<b>ORDINARY MEETING</b>	<b>5.3</b>
<b>5 MAY 2015</b>

RECONFIGURING A LOT (1 LOT INTO 5 LOTS) – 1L OASIS DRIVE WONGA  
**J Elphinstone, Senior Planning Officer: ROL 209/2014 #451776**

<u>PROPOSAL:</u>	RECONFIGURING A LOT (1 LOT INTO 5 LOTS)
<u>APPLICANT:</u>	FLORO PTY LTD C/- CHARLES O'NEILL SURVEYORS & PLANNERS PO BOX 5246 CAIRNS QLD 4870
<u>LOCATION OF SITE:</u>	1L OASIS DRIVE WONGA
<u>PROPERTY:</u>	LOT 1 ON SP259953
<u>LOCALITY:</u>	COASTAL SUBURBS
<u>PLANNING AREA:</u>	TOURIST AND RESIDENTIAL
<u>PLANNING SCHEME:</u>	DOUGLAS SHIRE PLANNING SCHEME 2008
<u>REFERRAL AGENCIES:</u>	NOT APPLICABLE
<u>NUMBER OF SUBMITTERS:</u>	NOT APPLICABLE
<u>STATUTORY ASSESSMENT DEADLINE:</u>	EXPIRED
<u>APPLICATION DATE:</u>	1 AUGUST 2014
<u>APPENDIX:</u>	<ol style="list-style-type: none"> <li>1. PROPOSAL PLAN(S) &amp; DOCUMENT(S) TO BE AMENDED BY THE CONDITIONS OF THE APPROVAL</li> <li>2. INFRASTRUCTURE CHARGES NOTICE</li> <li>3. SUPPORTING INFORMATION TO PLANNING REPORT</li> </ol>

**Plan of Proposed Lots**  
1-5  
**Cancelling**  
Lot 1 on SP259953

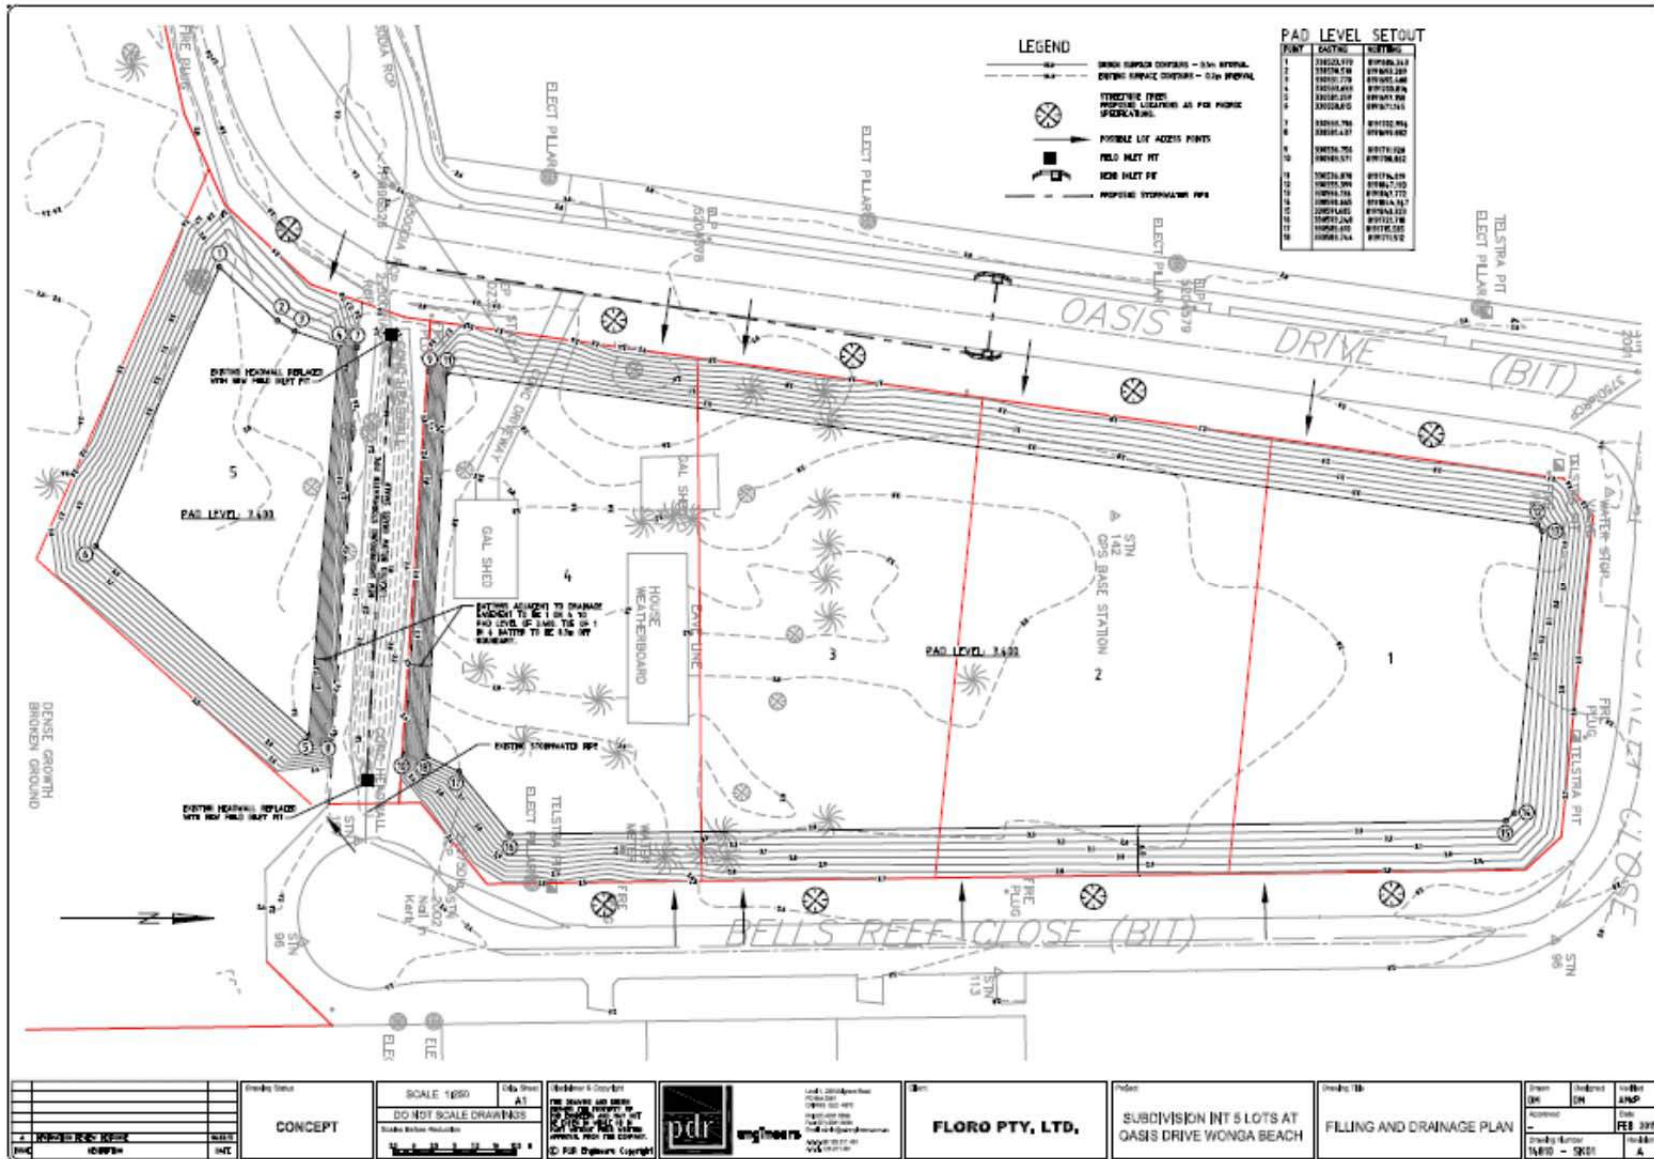
4. The lot fill design is to be generally in accordance with PDR Filling and Drainage plan 14810 – SK01 Revision A dated February 2015 subject to:
  - a. Setback of fill areas a minimum of 6m from the property boundary from all roads.

- b. A minimum fill pad of 1000m<sup>2</sup> must be provided for each lot.
  - c. Fill lots in compliance with condition 9 below;
  - d. The fill pads for proposed Lots 3 and 5 are to be extended to the southern boundary of each lot and retained;

- e. Appropriate protection is to be provided to prevent non authorised vehicles from entering the drainage easement including at a minimum, Barrier Kerbing. The applicant is to assess the need for additional barriers and or landscaping in these areas;

- f. Delete the vehicle access from Bells Reef Close for proposed lot 5; and
  - g. Any amendments required to comply with the conditions and the requirements of Queensland Streets and the FNQROC Development Manual.

9. The concept for excavation and earthworks as detailed on PDR Engineers Fill and Drainage Plan Drawing 14810 – SK01 Revision A dated February 2015 is generally approved subject to compliance with the on-site disposal and drainage conditions and subject to the following amendments:
  - a. The earthworks fill zones are to be continuous to the southern boundaries of Lots 3 and 5;
  - b. For lots 1, 2, 3 and 5 the nominated fill level of 3.4m is to be increased to 4.04m AHD level unless otherwise approved by Council. Any reduction below 4.04m AHD must be supported by a further study, to the satisfaction of Council, to a lower level than 4.04 but no lower than 3.54m AHD. Any reduction below 4.04m AHD must utilise at least a 0.3 Sea Level Rise (SLR) and increase in intensity of cyclone action.
